**Re: Docket 50-326 Relicense, RAI dated April 5, 2011 (TAC ME1579),
additional response material - extension granted to August 1st, 2011.**

A. Attached is a complete revision of SAR 13.2 addressing the MHA for the UCI Reactor Facility and removing material from the 1968/1999 SAR that is no longer required.

University of California – Irvine (UCAI)
License No. R – 116
Docket No. 05000326

Response to RAIs Dated April 5, 2011 (TAC ME1579), Additional Response Material –
Extension Granted to August 1st, 2011

Figure 3-1 Reactor facility ventilation and air conditioning system

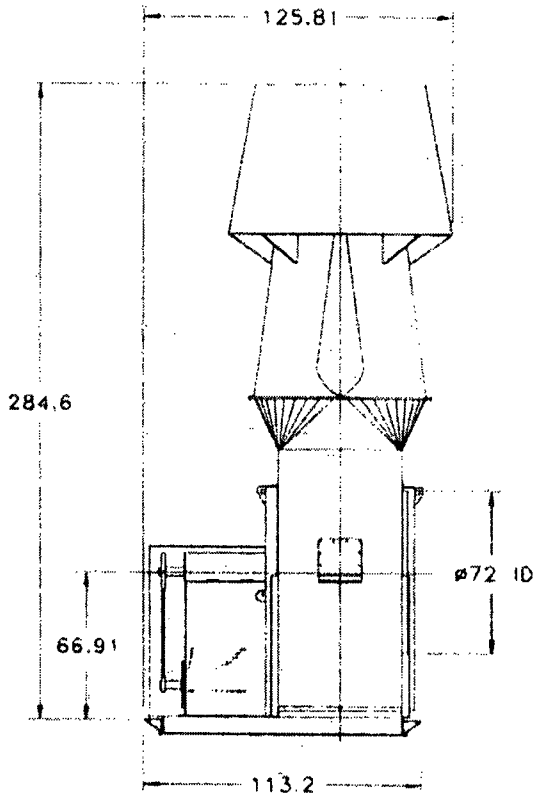
The ventilation system for this area is diagrammed in Fig. 3-1. In normal operation, fresh air is drawn into the building at the service floor level via two air handling units equipped with filters and hot and chilled water coils. The airflow is split to form a hot and cold deck supply distribution system for the building. Three supply valves supply the control room, the reactor room and the rear laboratories respectively. A local thermostat controls mixing dampers at the entrance to each supply area to maintain room temperature. Temperatures and static pressures in the main supply ducts are maintained by automatic controls on the Phoenix valve flow dampers. Exhaust ducts are controlled in a similar manner to maintain the negative pressures requirements. The complete system is under the control of the Central Plant which is manned 24 hours a day.

In emergency mode, air is exhausted from the reactor room at a rate of about 250 cfm through a Magnamedia Beryllium-collector style filter. At the same time, supply valves (Fig. 3-1) to the reactor room and laboratories are closed and the regular reactor room exhaust and the fume hood exhaust control valves are closed. The pneumatic transfer system blower is disabled, and audio and visual alarms indicate that an emergency condition has been actuated. Flow rates can be monitored at the control room ventilation system controller to assure this has been accomplished.

Figure 3-2 Rowland Hall roof exhaust fan Axijet S 6600 details

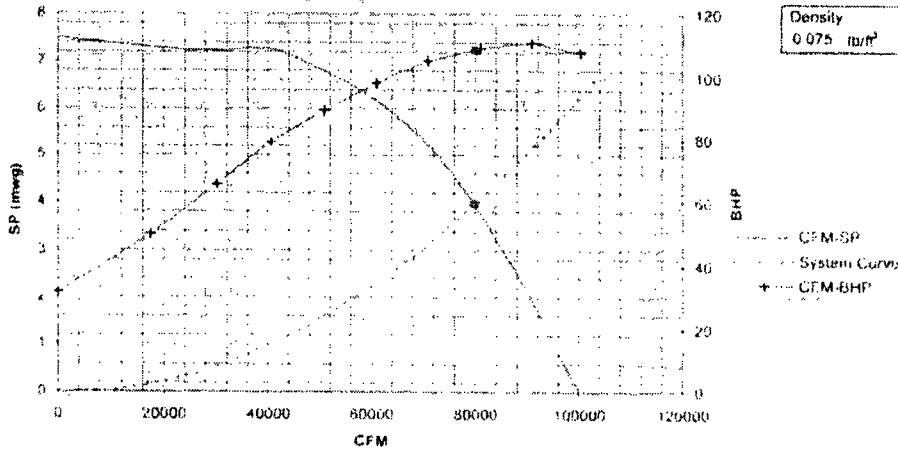
The ventilation system (SAR Section 3.6) discharges the emergency purge exhaust into the main building exhaust which has three exhaust fans designed to create a flow of $3 \times 80,000$ cfm, further diluted to $3 \times 128,000$ cfm at a height of 120 feet above the building roof by means of Axijet® structures. From that point, natural dispersion, aided by the jet stream, will further dilute the effluents.
